**AGENDA
CITY OF STURGEON BAY
AESTHETIC DESIGN & SITE PLAN REVIEW BOARD**

Monday, March 14, 2022

To: Aesthetic Design and Site Plan Review Board
From: Christopher Sullivan-Robinson
Date: March 9, 2022
Subject: Project Review – 911 Green Bay Rd

NORTH ELEVATION

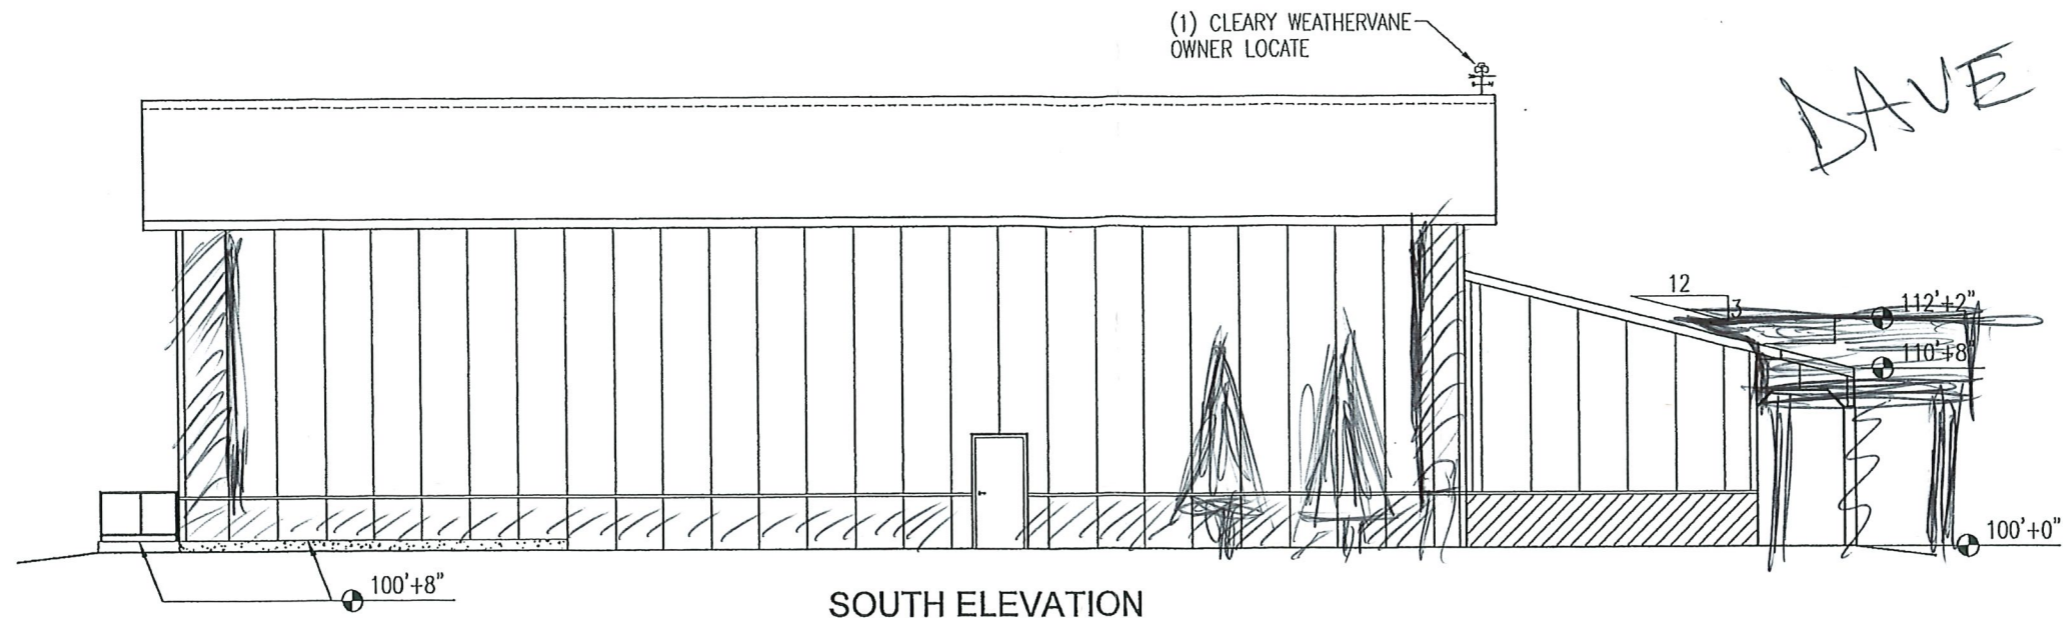
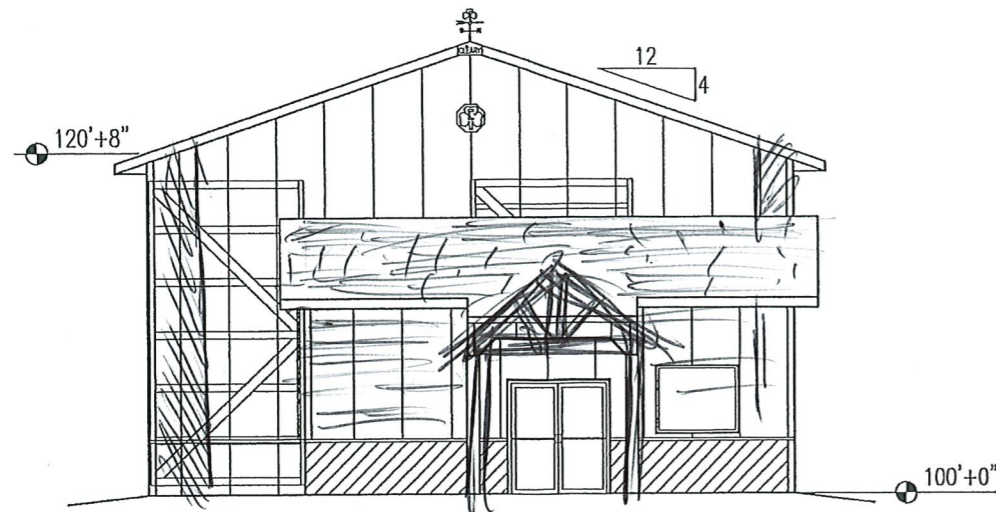
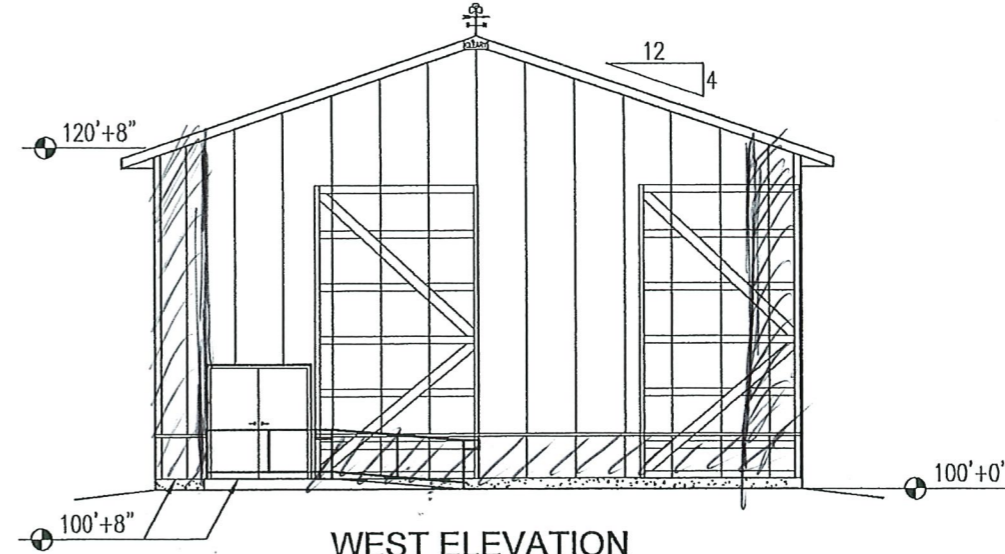
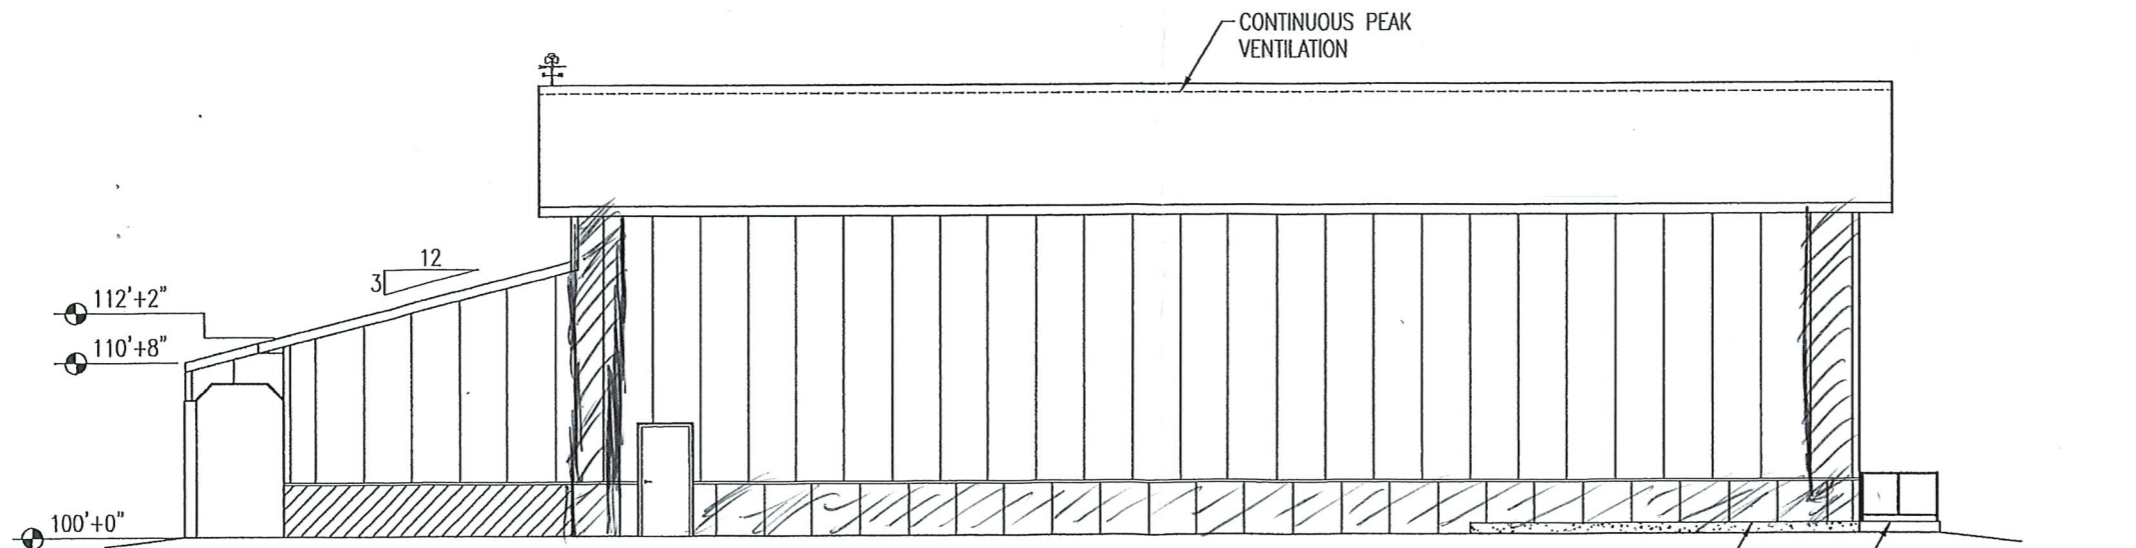
Mr. Augustson stated the building is very tall and the sides of the building are pretty much empty, so questioned the landscaping and how many trees. Mr. Champeau indicated he is working with a landscaper to give him an idea how many trees. Mr. Champeau stated he likes the cluster of trees Maritime currently has. Mr. Augustson asked Mr. Champeau if the landscaping plan will be presented in the near future along with a lighting plan, Mr. Champeau confirmed. Mr. Augustson stated if light poles are going in the parking lot need to confirm the lighting for neighbors. Presenter, Ms. Lola Devillers, stated the intentions are to mimic the lighting Maritime Hotel currently has in place with the same down lighting. Mr. Struck indicated the committee needs to see a plan. Mr. Sullivan-Robinson indicated the lighting, signage, and landscaping will need to come back to the committee in the future, only looking at the building for approval. Mr. Wiesner expressed this is a pole building which is long and tall, unsure what landscaping is going to look like or add to the building without a visual plan. Mr. Wiesner suggested adding more color or trees to help hide come of the building and break it up. Mr. Champeau requested a landscaping recommendation to provide to the landscaper, Dave Berkin. Mr. Wiesner stated the downfall of adding a large number of trees will take away from parking. Mr. Champeau stated the parking lot design was updated angling the parking spots to accommodate another 6-8 feet for landscaping. Mr. Struck stated try to shy away from metal buildings and

suggesting, bringing the bronze wayne's coating higher up the building to divide the building in half. Mr. Wiesner questioned raising to six feet with the wayne's coating instead of 3 feet. Mr. Burk questioned if the sides of the building are visible to those driving by on 14th and it was confirmed. Ms. Devillers stated 14th is not a high traffic area like Egg Harbor Road, Mr. Wiesner disagreed indicating one of the well-traveled areas. Ms. Jorns questioned if any landscaping is on the lot line between Maritime and their property, Ms. Devillers explained the only trees behind the property nothing in-between. Mr. Struck suggested making the rest of the building all bronze and adding trees to hide the building and leaving the front, as the front of the building is what should stand out. Mr. Champeau disagreed as his experience with past buildings, one color buildings aren't attractive. Mr. Champeau indicated at this time cannot change the materials on the building due to being ordered, if they were to change would be costly. Mr. Wiesner stated procedure is to get approved before ordering materials.

Mr. Augustson wanted clarification the stone is real, not vinyl. Mr. Champeau verified its cornerstone brink, not stacked brick. Mr. Augustson questioned not a masonry doing the stone, Mr. Champeau indicated no. Mr. Augustson suggested on the outside corners adding antique bronze accent panels, Mr. Champeau agreed. Mr. Augustson suggested the stone being darker than the upper shingles, Ms. Devillers will research different stone.

Mr. Burk made a motion to accept as presented upon approval of landscaping plan to soften the building side walls along with a lighting plan and signage. Seconded by Ms. Jorns. Mr. Augustson made an amendment to add the corner details as drawn by Dave Augustson and darker stone to be approved by the Chairman. Seconded by Mr. Struck. All in favor. Carried.

PROPOSED
SITE / UTILITY
PLAN

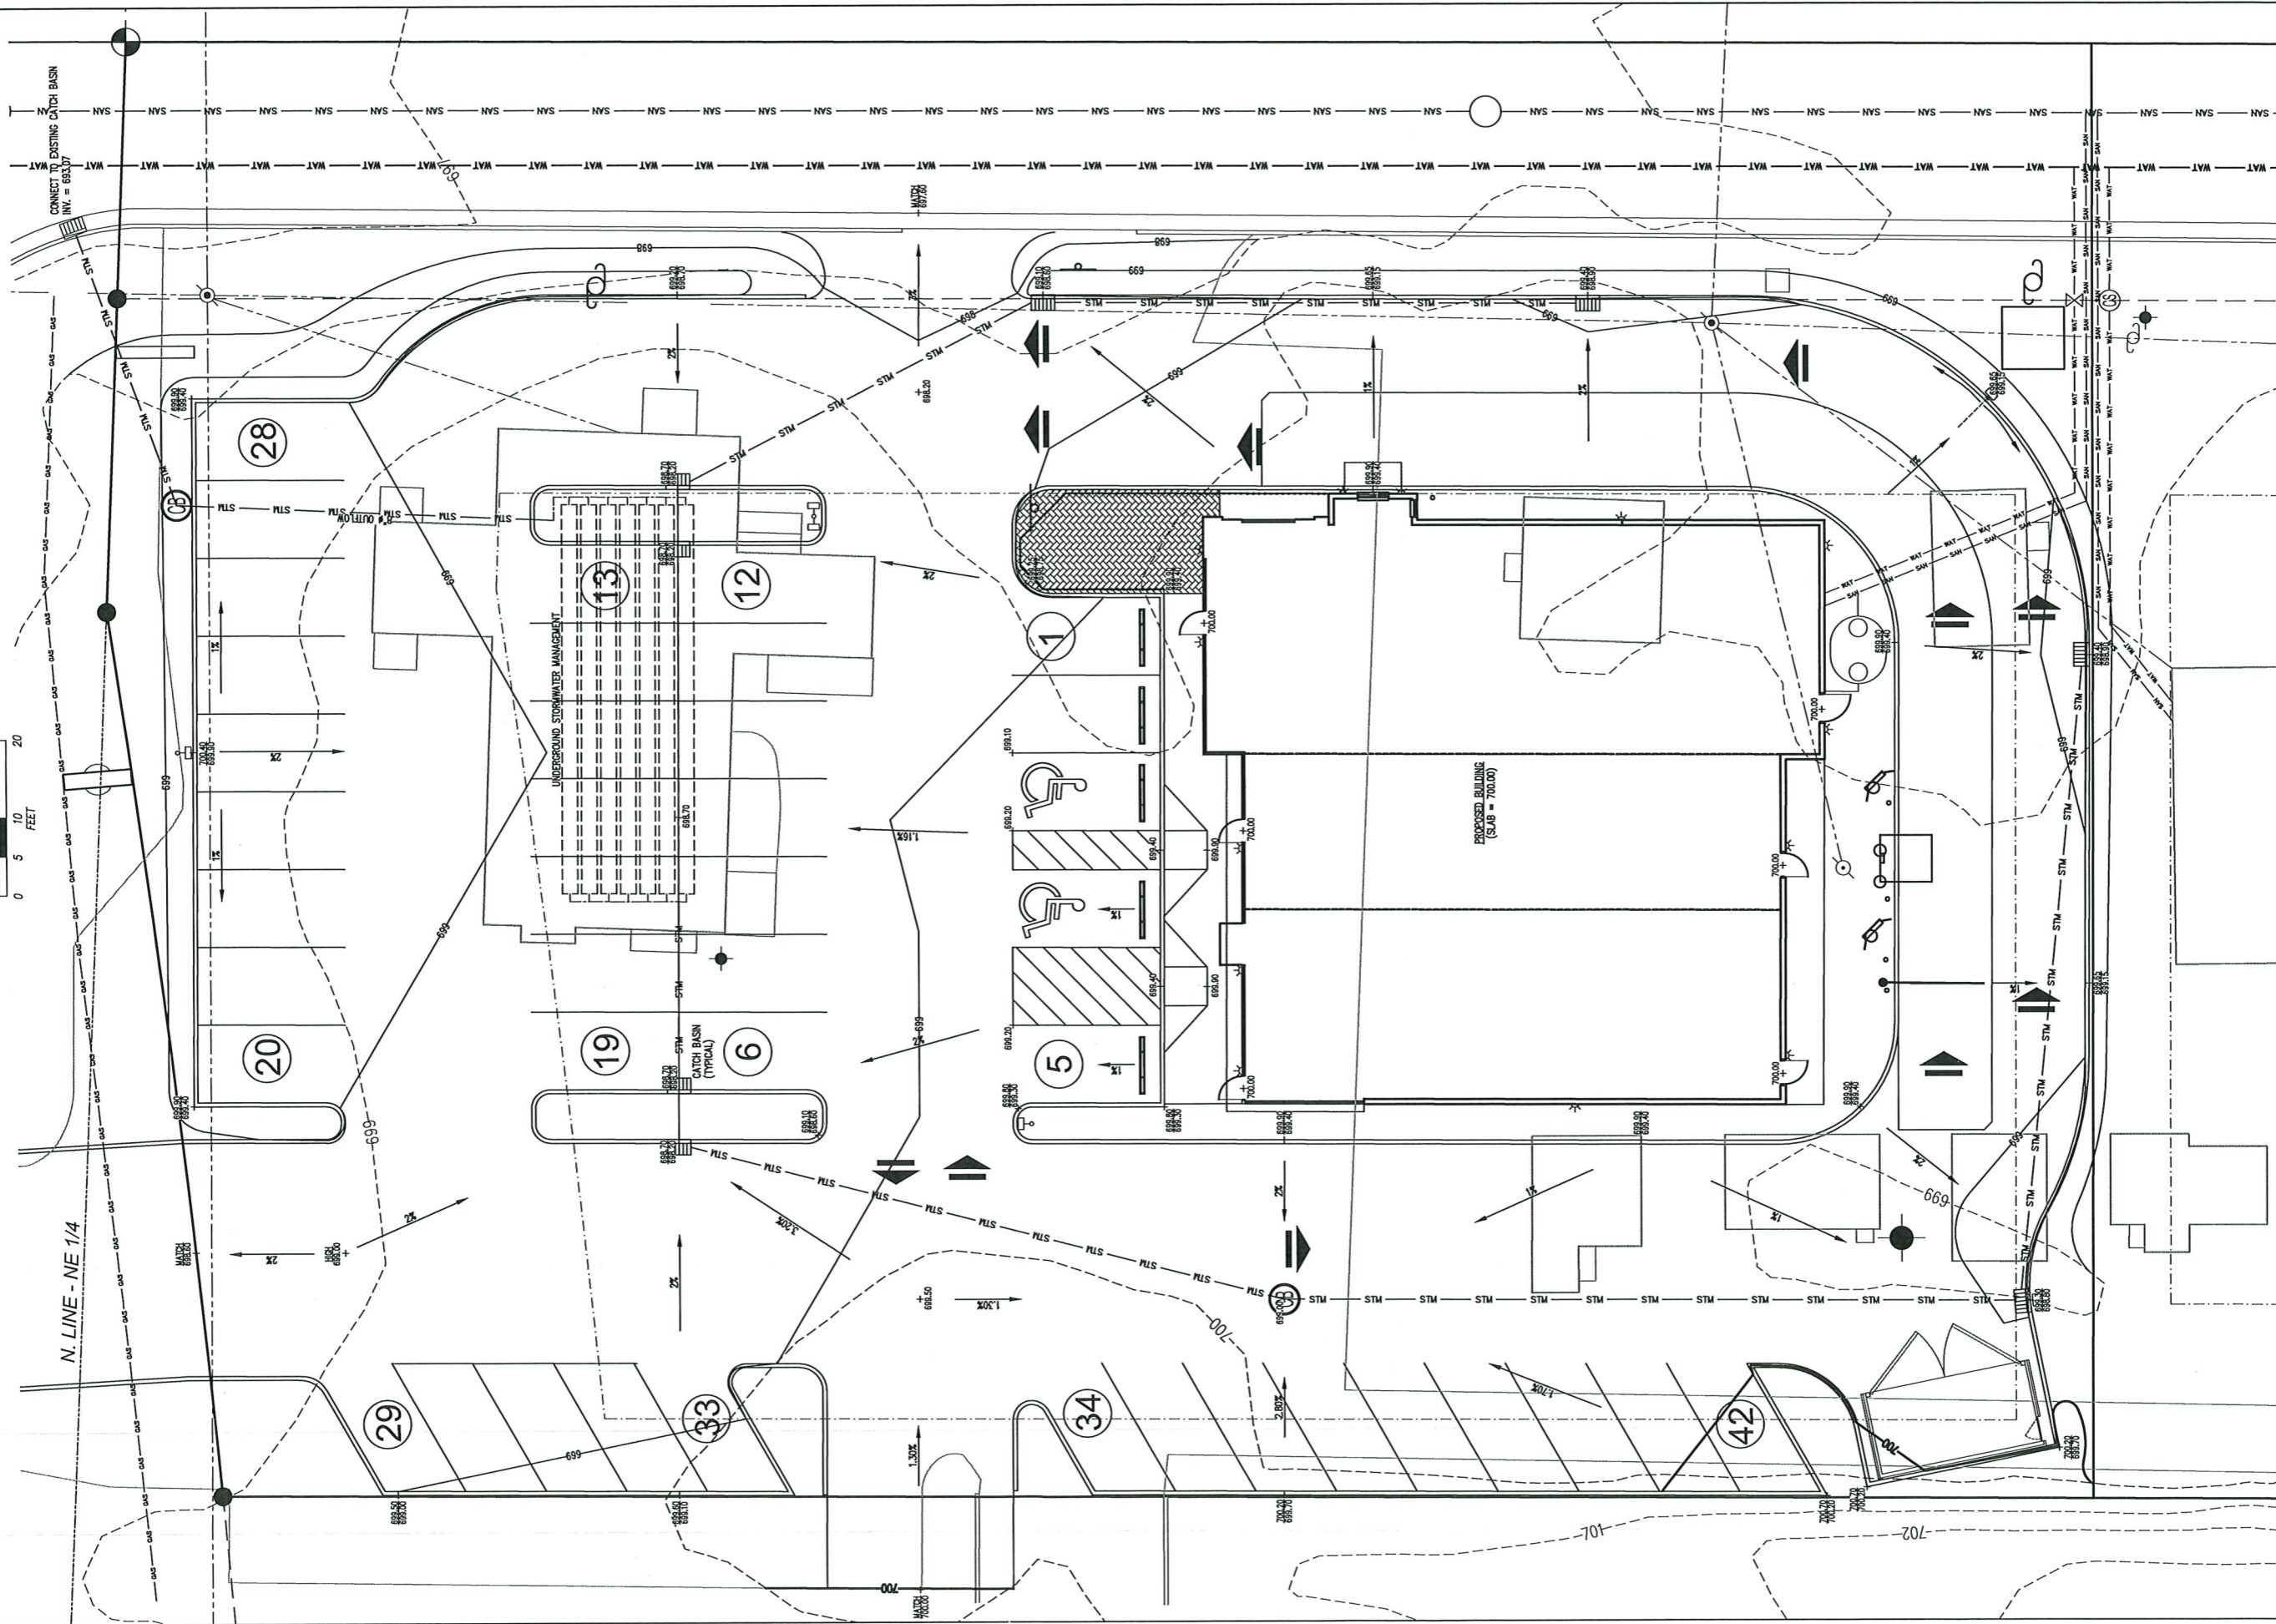
There are sidewalks proposed along the building frontage. There are no public sidewalks within this area. This is something the committee could consider.

(d) Off-street parking located to the rear or side of buildings is preferred over parking between the building and the street, particularly if the amount of off-street parking supplied is greater than required under the zoning code. For stand-alone buildings under 15,000 square feet, it is preferable that not more than one tier (single row or double row) of parking be located between the building and the street it fronts.

This should be considered by the committee since the amount of parking exceeds the required amount to meet the zoning code.

Please review the project plan for stormwater management. No permeable surfaces are proposed. However, this could be considered by the committee as there is a large amount of impervious surface.
